Technical Service Bulletin

**LIGHT RESISTANCE AND/OR UNUSUAL NOISE WHEN TURNING
STEERING WHEEL TO THE LEFT**

Bulletin No.: 06-005/19

This bulletin supersedes the previously issued bulletin(s) listed below. The changes are noted in Red text.

[R] Parts (*1) (*2) Location:

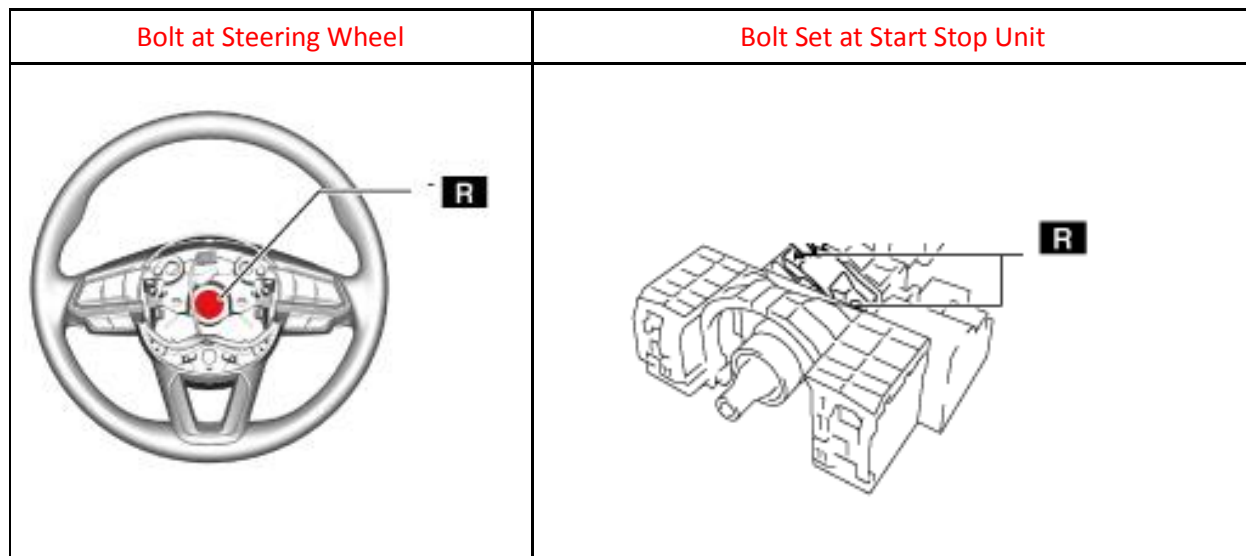
Parts Number	Description	Qty.	Notes
DA7H-32-100N	Shaft, Steering	1	2016-2017 Mazda2
DG7L-32-100D	Shaft, Steering	1	2018 Mazda2
DB4G-32-100J	Shaft, Steering	1	2016-2017 CX-3
DH1E-32-100C	Shaft, Steering	1	2018 CX-3
B455-32-099B	Shaft, Bolt	1	[R]
D10J-32-099	Shaft, Bolt	1	[R]
9YA0-11-003A	Bolt	1	[R] (*1)
KA01-66-154	Bolt, Set	2	[R] (*2)
